**ADDENDUM NO. 003**

**RE:** Dobyms-Bennett High School  
Phase 1 Renovation  
Project 19800

**DATE:** 5-6-2026

# Model G500-B

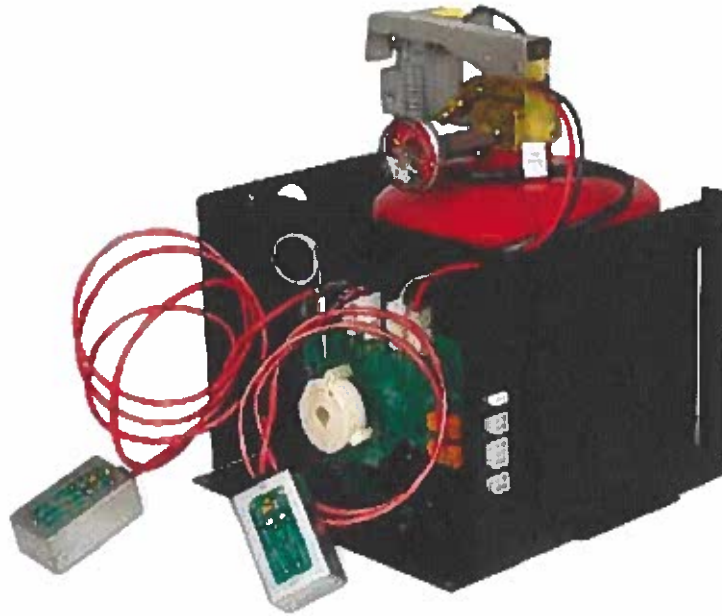
Provide and install Guardian Safety Solutions G500-B Hood Fire Suppression System. Include hardwired shutoff for range power and G502-INT Interface for connection to building power and fire alarm. Please see the attached for this item.
